-Regular Meeting Minutes CAPITAL PROJECT BUILDING COMMITTEE Wastewater Treatment Facility Conference Room

Update on the WPCF Phosphorus Removal Upgrade Project:

CR-06 - Summary Information

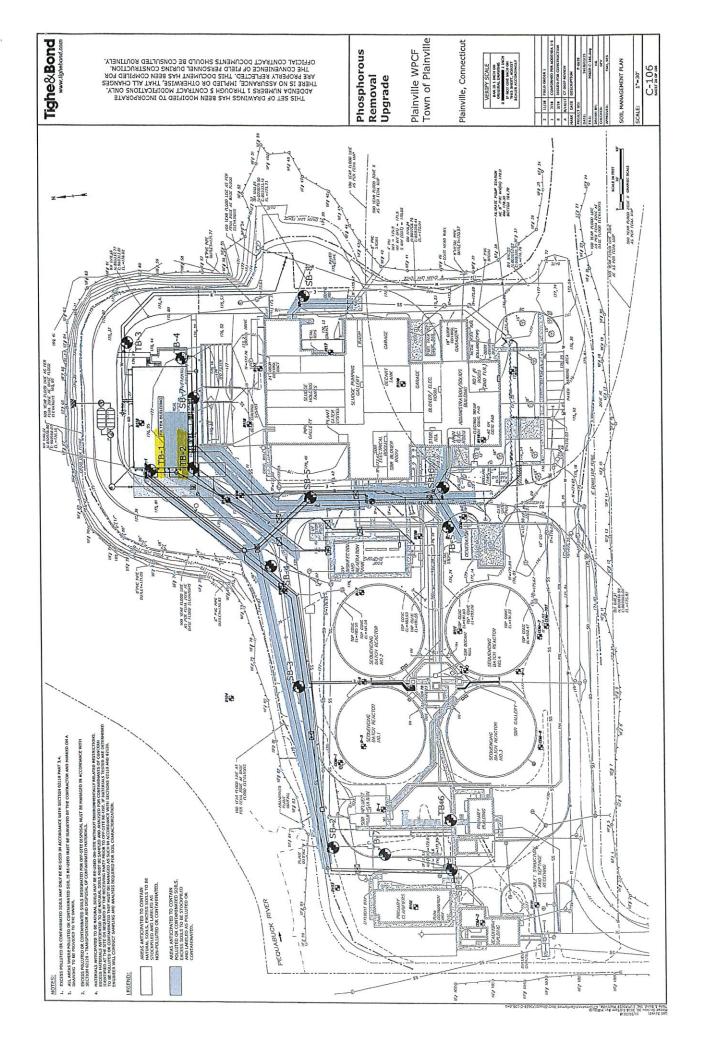
There were two borings provided at bid time which were located on the west side of the Filter Building, TB-1 and TB-2. Attached drawing C-106 has these two locations highlighted. Borings TB-1 and TB-2 did not indicate any shale, the boring information is also attached. The second drawing in the attachment, C-104, shows where shale was found, a photo is also included. There is no way this shale could have been anticipated based on provided information.

The shale acted as a conduit, water flowed through the shale into the excavation even though the shale was above the level of the water table.

There were no test pits in the area of the Filter Building, in addition test pits were completed after the job was underway. The test pit locations are indicated by a rectangle with an X on the attached C-106.

The issue caused by the layer of shale which acted as a conduit was further compounded by the abnormally high amounts of rain and subsequent river flows. Flow levels for the Pequabuck River which runs immediately behind the Filter Building are also included.
